DEPARTMENT OF THE ARMY

Re: Proposed Temporary Groundwater Sampling Plan for Parcel 38 Former Outdoor Pistol Range (1940-1955), Main Post, Fort Monmouth, N.J.

Re: March 2012 Army Response to NJDEP Correspondence Letter Dated October 28, 2008
Fort Monmouth, NJ
PI G000000032

Figure 1
Proposed Temporary Groundwater Sampling Point Location Map
Parcel 38 Former Outdoor Pistol Range (1940-1955)
Main Post, Fort Monmouth, N.J.

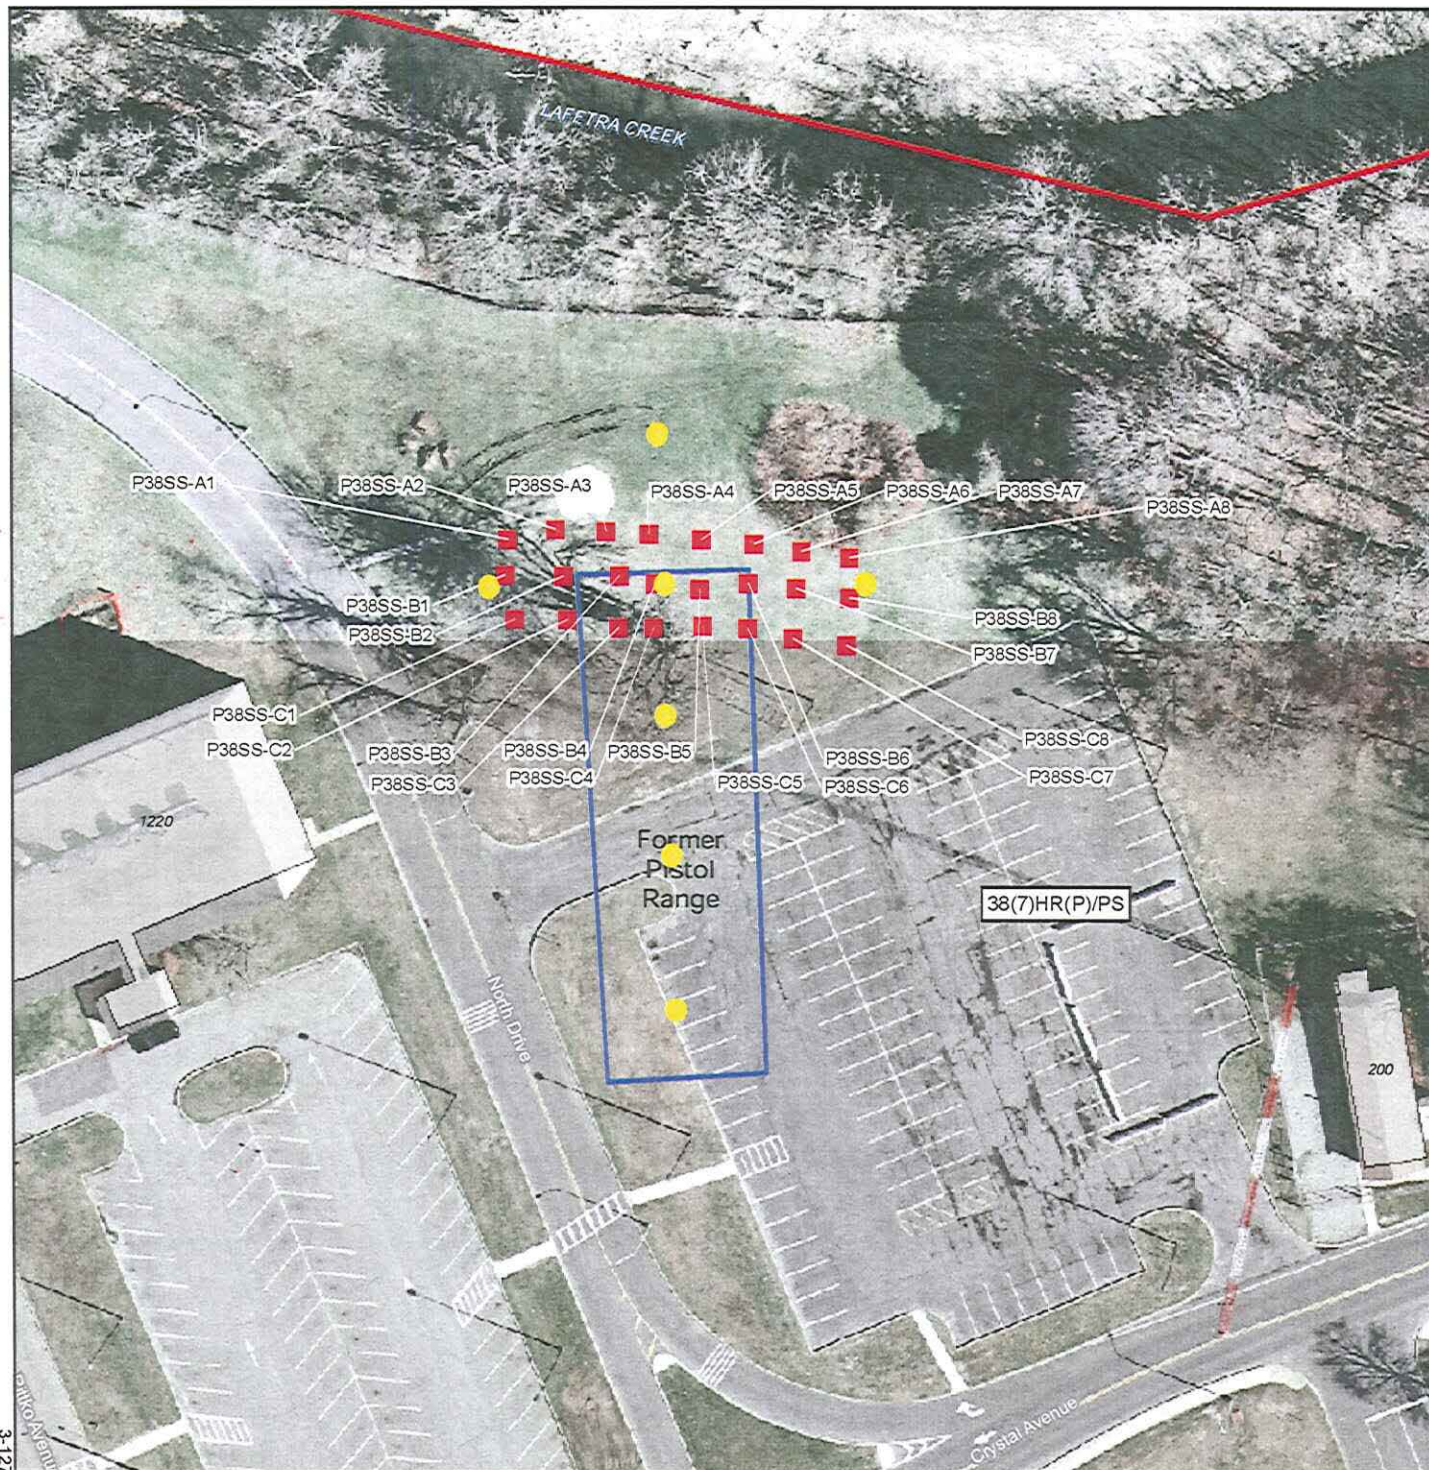
Although no exceedences were noted, Departmental comments indicated the surface soil sampling was not adequate due to the possibility the parcel soils had been re-worked; a ground water investigation was therefore required. The Army will be submitting the results of a ground water investigation in a future letter report to this office. If you wish to receive comments on anticipated frequency and locations of the ground water sampling points and methodology (ie low-flow), please submit the sampling plan prior to implementation.

A scaled site map depicting seven proposed groundwater sampling locations is provided in Attachment B. Groundwater samples are proposed to be collected via Geoprobe® installation of temporary groundwater sampling points, in accordance with the NJDEP's August 2005 *Field Sampling Procedures Manual*. Collected groundwater samples will be submitted to a NJDEP-certified laboratory for lead analysis only.
